PRODUCT / PROCESS CHANGE NOTIFICATION

1.1 Company	 STMicroelectronics International N.V
1.2 PCN No.	ADG/23/13978
1.3 Title of PCN	DPAK new Lead Frame design-Tongfu Microelectronics (TFME) - INDUSTRIAL
1.4 Product Category	Power MOSFET
1.5 Issue date	2023-03-17

TFME (type C2)

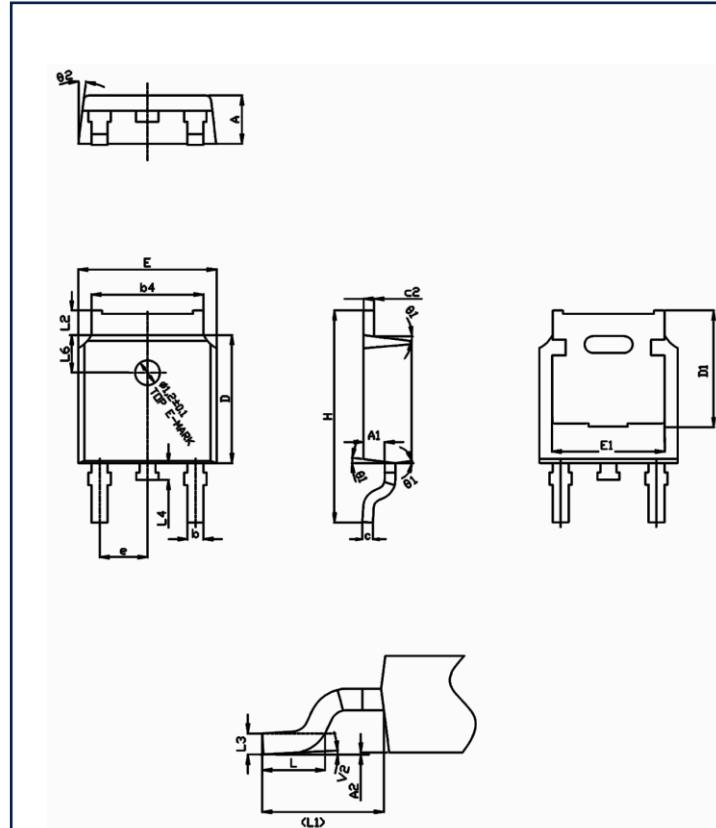
Differences	
TFME (type C2)	TFME (type C3)
A1 = A2	
A2 = A1	
L2 = L3	
L3 = L2	
V2 = Θ

TFME (New)

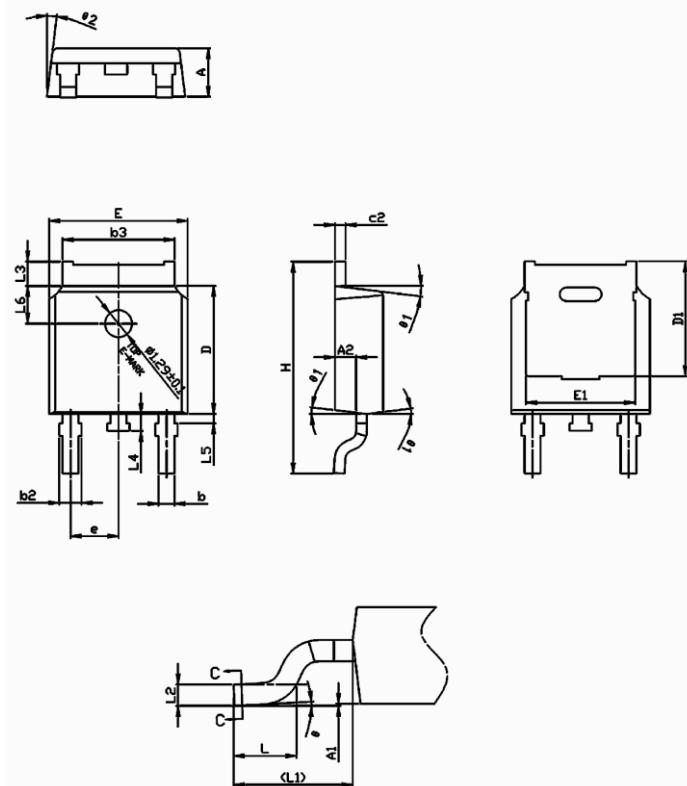
Old	New
4.1 Description	DPAK Industrial package produced in Tongfu Microelectronics (TFME), is manufactured with Standard Die Pad lead frame	DPAK Industrial package produced in Tongfu Microelectronics (TFME), is manufactured with Large Die Pad lead frame
4.2 Anticipated Impact on form,fit, function, quality, reliability or processability?	processability
